APPENDIX A

URBAN DESIGN EVALUATION OUTCOMES & OPPORTUNITIES

GREAT SOUTH ROAD 1

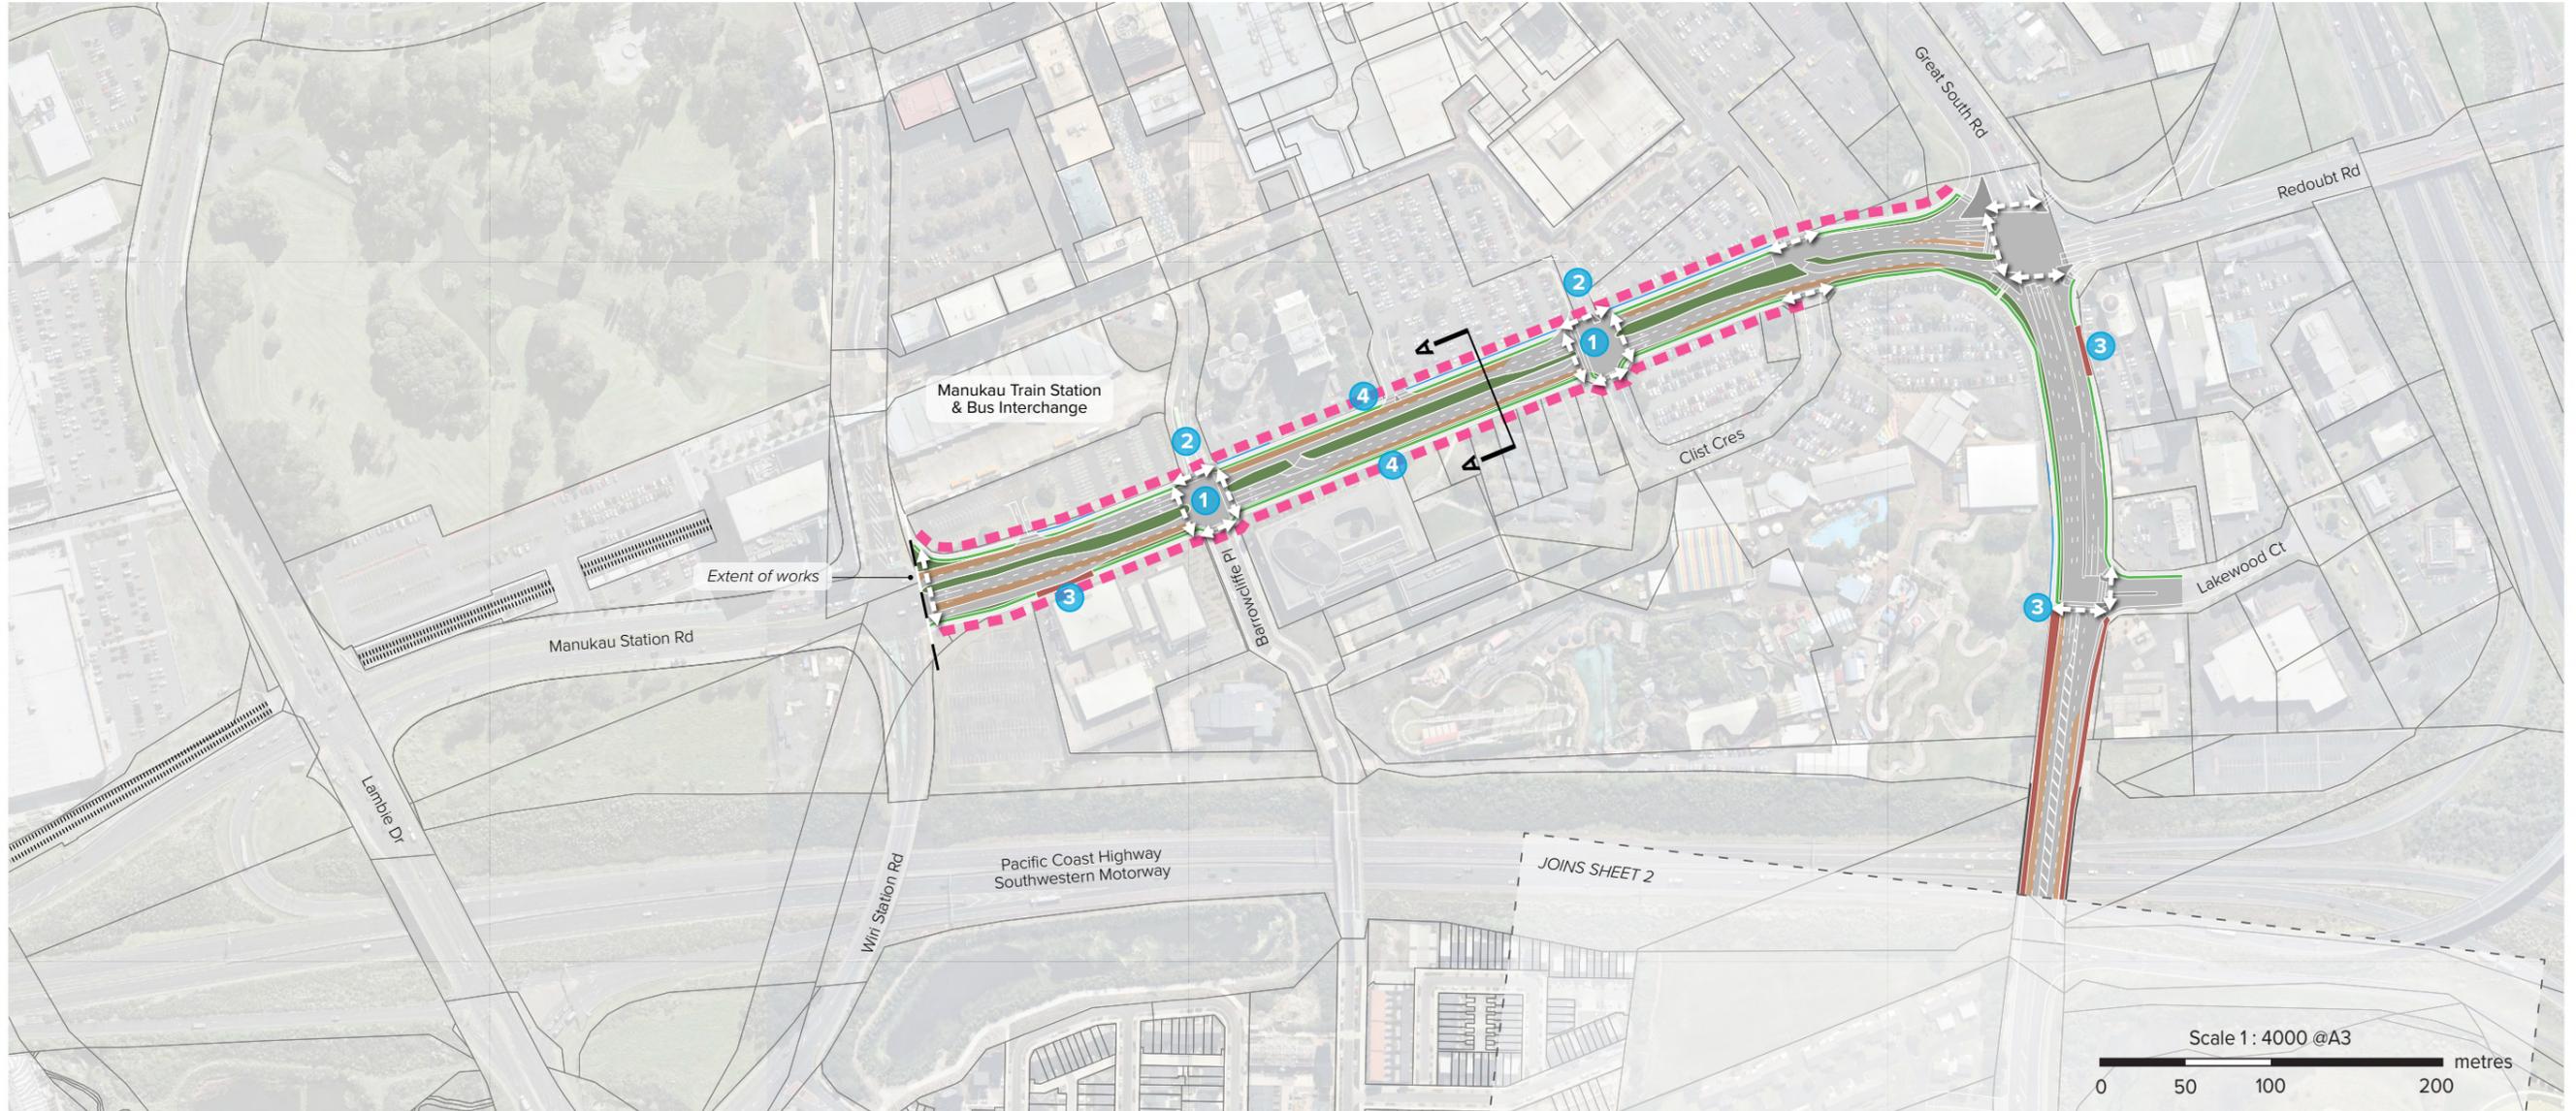
- 1 Active Mode Permeability**
 - Opportunity for appropriately placed and prioritised crossing points to reinforce a sense of personal safety, provide equitable local connectivity and continuity of 'primary/regional' active mode network.
- 2**
 - Opportunity for prioritised active mode connectivity into Davis Avenue and Osterly Way to connect to Manukau City Centre, Train Station and Bus Terminal.
- 3**
 - Consider safe tie in of active mode facilities on bridge and where separated active mode paths are constrained to shared use.
- 4**
 - Opportunity to further address an appropriate interface, connectivity at a fine grain pedestrian level and ability to support a people orientated street within the Manukau Metropolitan Centre.

SHEET 2

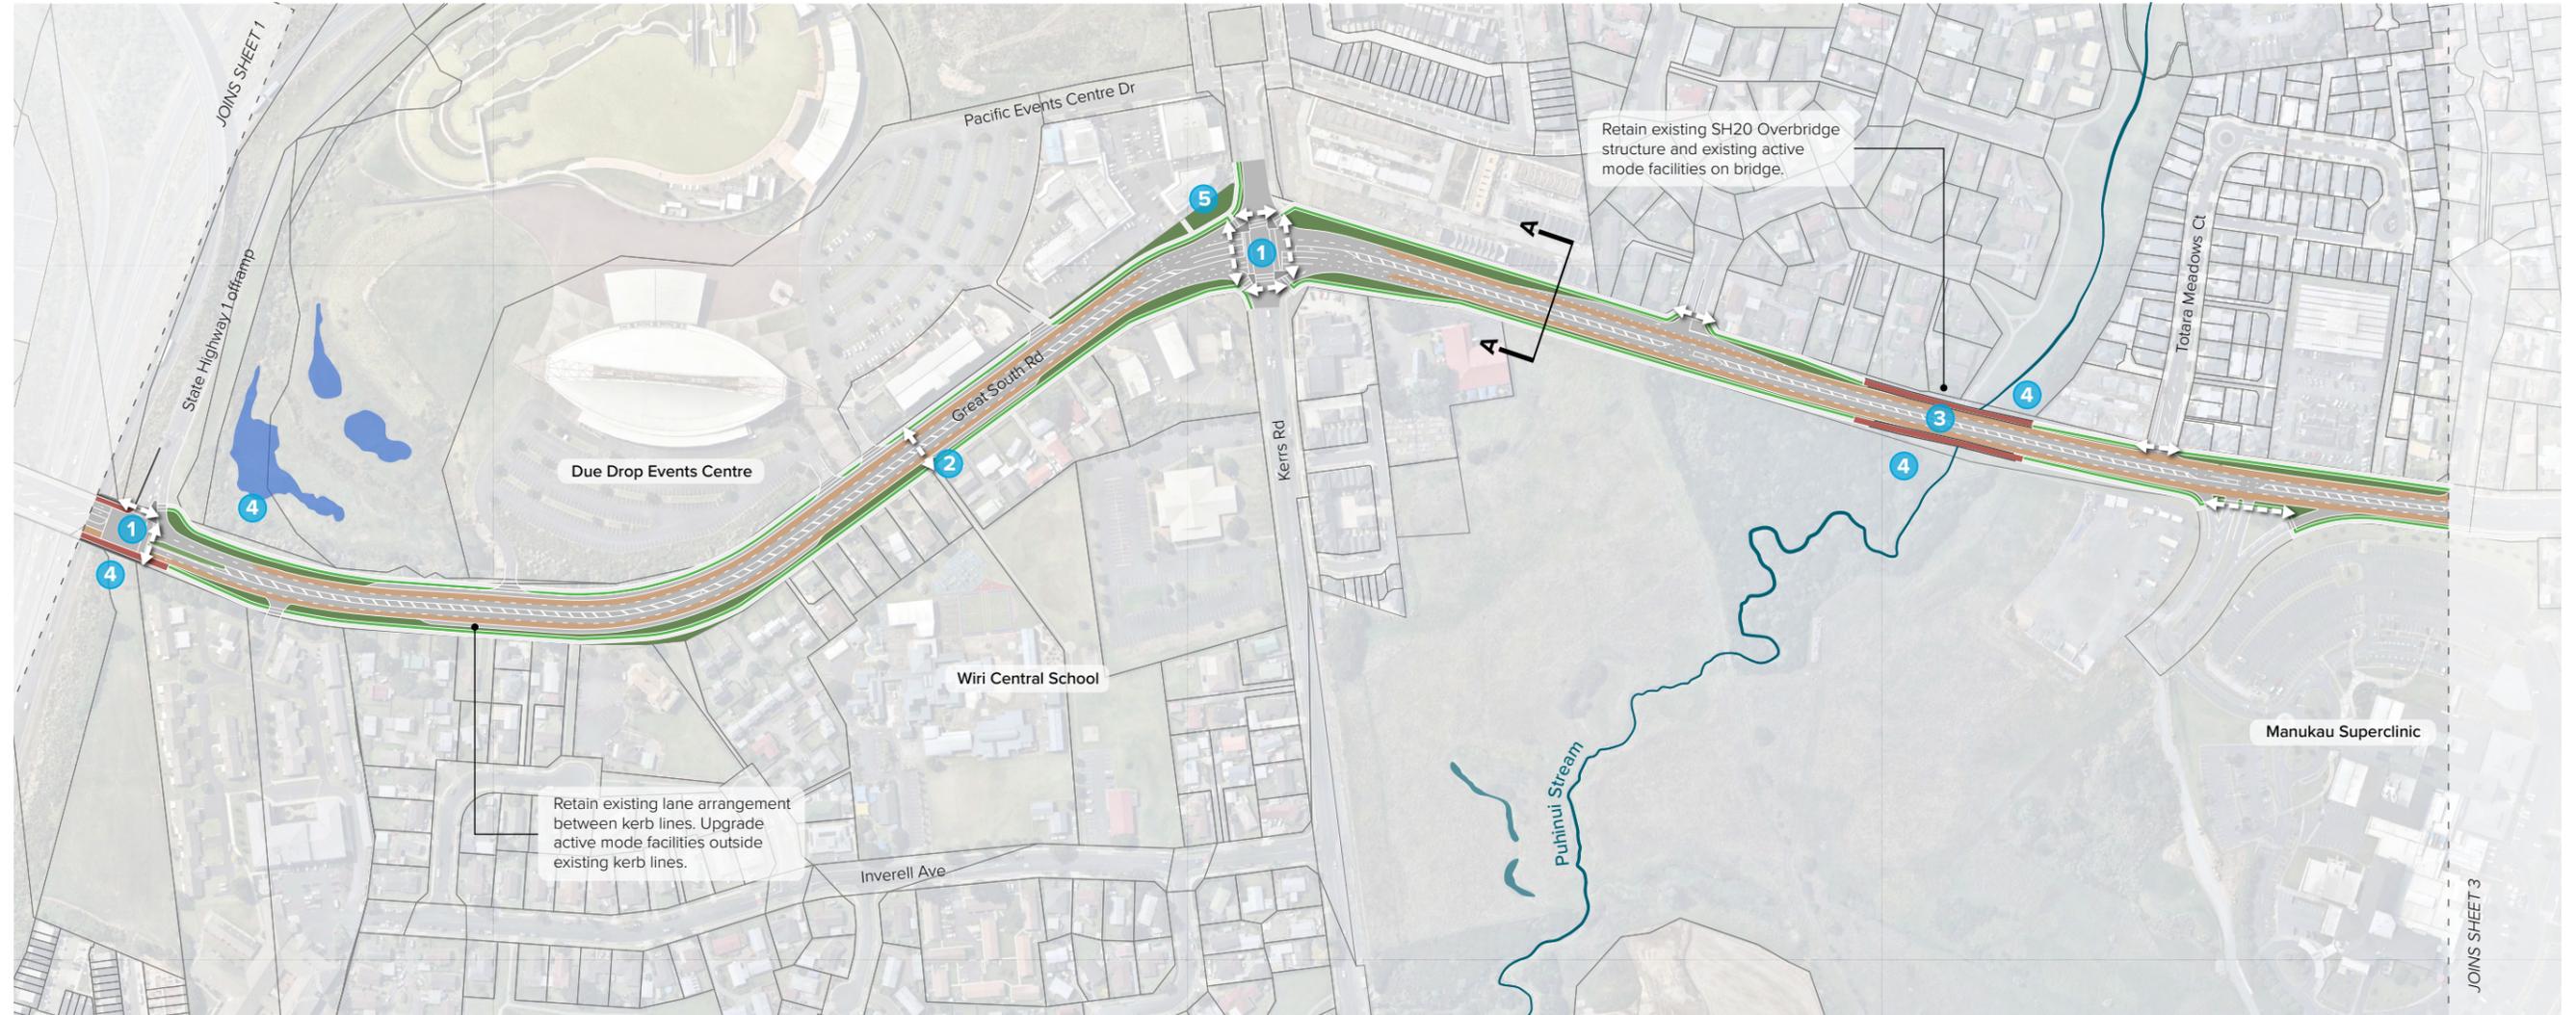
- 1 - Opportunity for appropriately placed and prioritised crossing points to reinforce a sense of personal safety, provide equitable local connectivity and continuity of 'primary/regional' active mode network.
- 2 - Opportunity for appropriately spaced apart mid block crossings to provide cross corridor connectivity and connect key local amenities such as entrance to Wiri Central School.
- 3 - Consider safe tie in of active mode facilities on bridge where separated active mode paths reduced to shared use.

- 4 - Opportunities for planting/water quality conservation through restoration/enhancement of existing open space/reserve areas as part of landscape response.
- 5 - Opportunity to support ecological outcomes through landscape response within berms.

- 1 Active Mode Permeability** - Provide prioritised active mode crossing points at intersections to enable equitable local accessibility and support connectivity with 'major/primary' role in wider active modes network.
- 2 Landscape Response** - Provide a landscape response to form an appropriate interface with Anderson Park. Demonstrate a corridor arrangement that avoids or mitigates impact to existing row of trees along the park edge.
- 3 Land Post Construction** - Redefine and integrate land post construction to support adjacent land use. Demonstrate reintegration of neighbourhood centres.

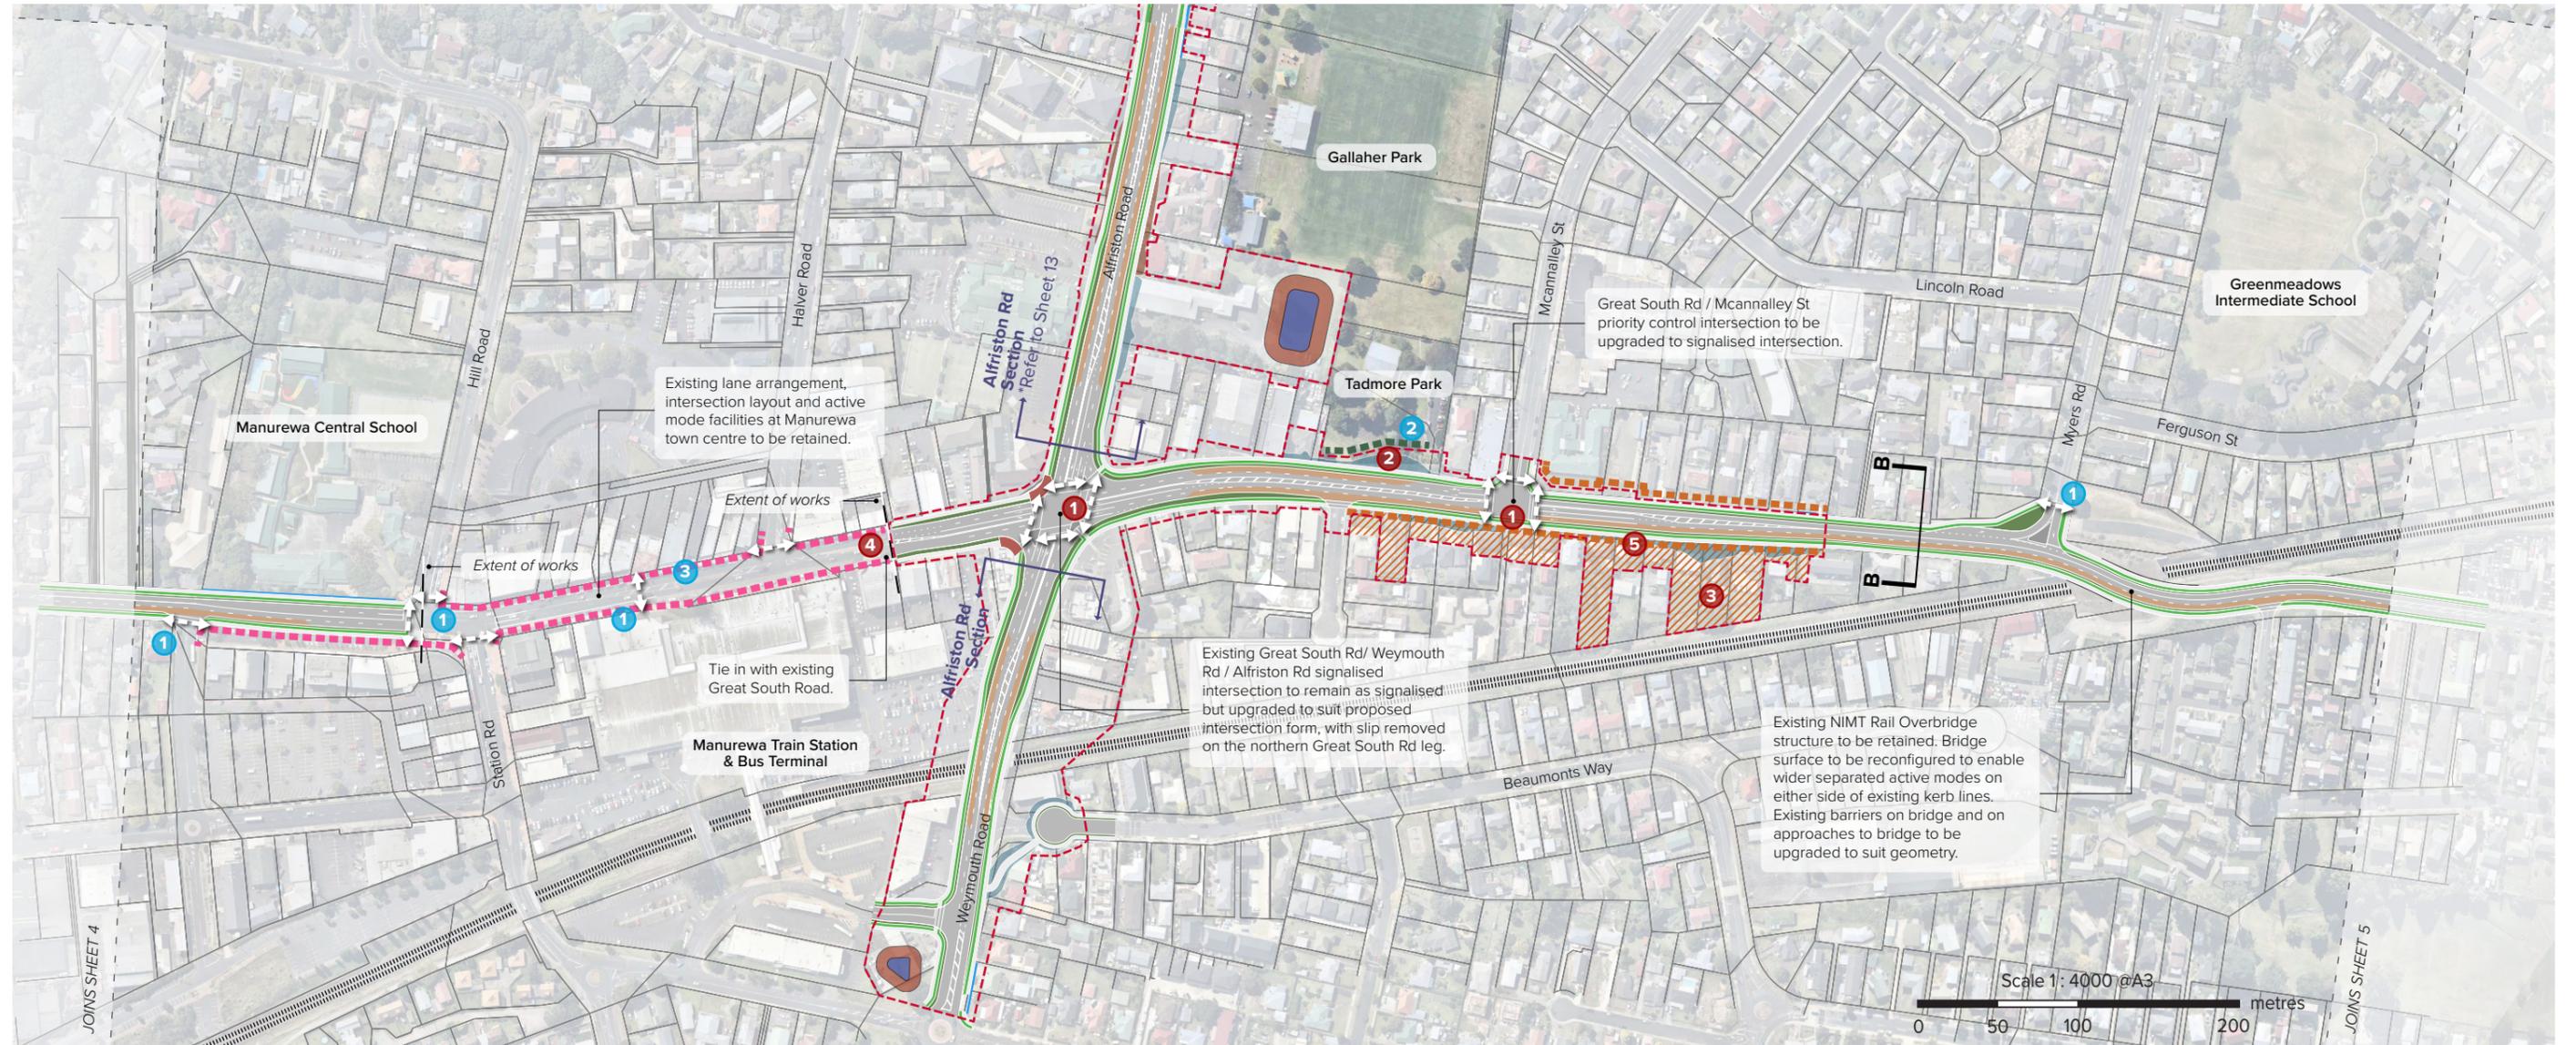
- 1** Opportunity for appropriately placed and prioritised crossing points to reinforce a sense of personal safety, provide equitable local connectivity and continuity of primary active mode network.
- 2** Opportunity to reintegrate adjacent land post construction to support the spatial accommodation of a neighbourhood centre.
- 3** Opportunities for further enhancement and definition of the park edge at Anderson Park through landscape response.

- 4** - Demonstrate integration of corridor with existing neighbourhood centres addressing an appropriate interface.
- 5** - Urban interface outcomes that provides pedestrian permeability, responds to public private interfaces and defines land post construction.

- 1 Active Mode Permeability** - Provide prioritised active mode crossing points at intersections to enable equitable local accessibility and support connectivity with 'major/primary' role in wider active modes network.
- 2 Landscape Response** - Provide a landscape response to form an appropriate interface with Tadmore Park. Demonstrate a corridor arrangement that avoids/mitigates impact to row of trees along park edge. Consider retaining structures where appropriate to reduce impact of potential earthworks.
- 3 Land Post Construction** - Redefine and integrate land post construction to support high density residential land use.

- 4** - Demonstrate appropriate integration of Manurewa Town Centre to address interface and tie in of active modes pathways.
- 5** - Demonstrate urban interface outcomes that responds to public private boundary. For example, consider appropriate visual screening, active frontages landscape response and building setback.

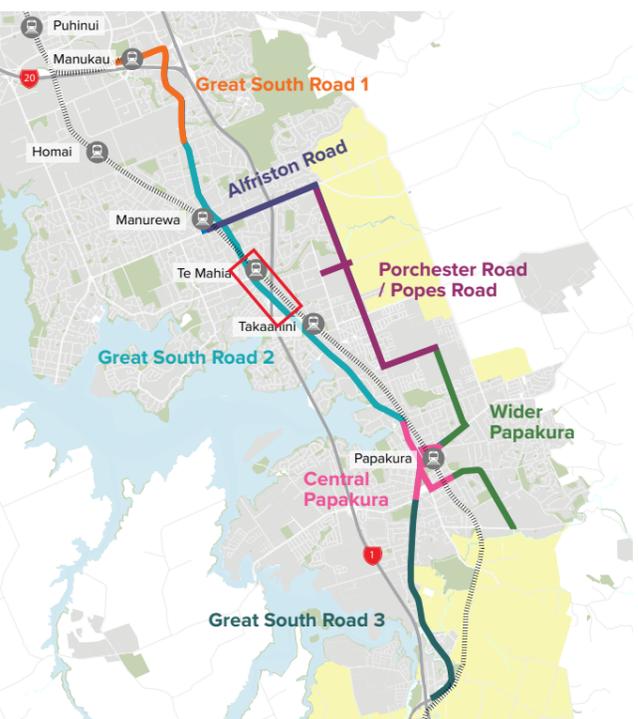
- 1** Opportunity for appropriately placed and prioritised crossing points to reinforce a sense of personal safety, provide equitable local connectivity and continuity of primary active mode network.
- 2** Opportunities for further enhancement and definition of the park edge at Tadmore Park through landscape response.
- 3** Opportunity to further address an appropriate interface, connectivity at a fine grain pedestrian level and ability to support a people orientated street within the Manurewa Town Centre.

- 1** Opportunity to enable significant connection for the community from Te Mahia Train Station through to Waiata Shores Esplanade and wider network. Consider extension of work to include active mode facilities over the Papakura Stream bridge as well as the enhancement of the train station entrance.

- 2** Papakura Stream bridge presents challenges to support a safe active mode environment. Consider opportunities to demonstrate safe outcomes through active mode crossing and tie in of pathways.

- 3** Te Mahia station entrance is an undesirable pedestrian environment with safety concerns, including poor visibility to the station, entrapment areas, and poor interface with the adjacent industrial properties. There is the opportunity to address this entry at future design stages which should seek to incorporate CPTED.

- 4** Takaanini interchange is a point for CPTED concern, isolation, and an undesirable pedestrian environment. Future design considerations should respond to and incorporate CPTED, including clear sightlines, appropriate planting and, good levels of lighting.

- 1 Active Mode Permeability**
 - Provide prioritised active mode crossing points at intersections to enable equitable local accessibility and support connectivity with 'major/primary' role in wider active modes network.
- 2**
 - Demonstrate convenient, safe and legible active mode connectivity to Te Mahia Train Station. Consider appropriate wayfinding, signage and landscape design to support and strengthen this connection.
